Access Compliance Report

Public Rights-of-Way

(Curb Ramps)

Intersection ID: 49894	Main Street: ROCKY_FORD_CLUB_RD	Cross Street: RUTH_FERRELL_CT	Location: NE
ADA ID: BFCF10998600	Ramp Type: Perp	Initial Pass/Fail: Pass	Overall Compliance: No
Codes/Mitigation Info/Possible Solution		Field Measurements/Component Compliance	
Severity Score: 7.75

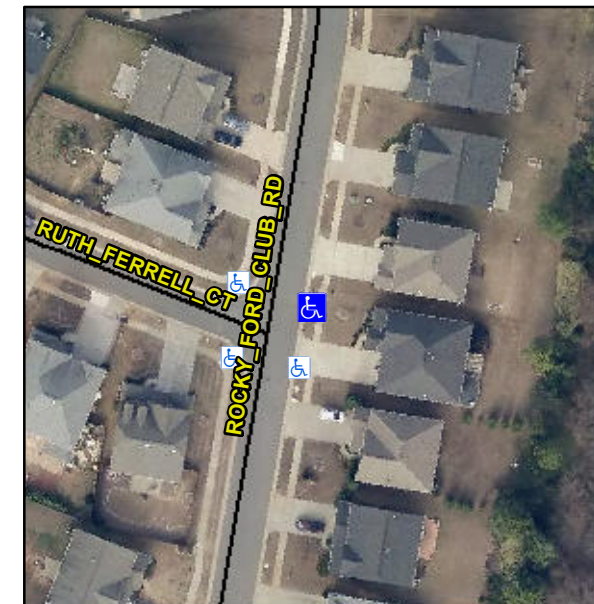
**Not Found, R304.5.3, R305.2,
R302.7.2**

Compliance	Description	Data	Compliance	Description	Data
N/A	Ramp Length (in)	72.0	Yes	Ramp Slope (%)	6.4
Yes	Ramp Width (in)	48.0	No	Ramp XSlope (%)	2.2
N/A	Flare Type LT	Sloped	N/A	Flare Type RT	N/A
N/A	Flare Slope LT (%)	6.8	Yes	Flare Slope RT (%)	9.5
N/A	Flare Traversable LT?	Yes	N/A	Flare Traversable RT?	Yes
Yes	Landing Length (in)	48.0	Yes	DWS Provided?	Yes
Yes	Landing Width (in)	48.0	Yes	DWS Contrast?	Yes
Yes	Landing Slope (%)	1.5	Yes	DWS Length (in)	24.5
Yes	Landing X Slope (%)	0.8	Yes	DWS Full Width?	Yes
N/A	Landing Curb? (Y/N)	No	No	DWS Offset (in)	5.5
N/A	Shared Landing?	No			
Yes	Gutter Ponding?	No	Yes	Gutter Slope (%)	3.4
No	Gutter Lip Ht (in)	0.5	No	Gutter X Slope (%)	2.2
N/A	Painted X Walk1?	No	N/A	Painted X Walk2?	N/A
	X Walk 1 Direction	To W		X Walk 2 Direction	N/A
N/A	X Walk 1 Width (in)	N/A	N/A	X Walk 2 Width (in)	N/A
	X Walk 1 Slope (%)	0.7		X Walk 2 Slope (%)	N/A
	X Walk 1 X Slope (%)	0.9		X Walk 2 X Slope (%)	N/A

**Remove & Replace Entire Ramp.
Remove & Replace Gutter.**
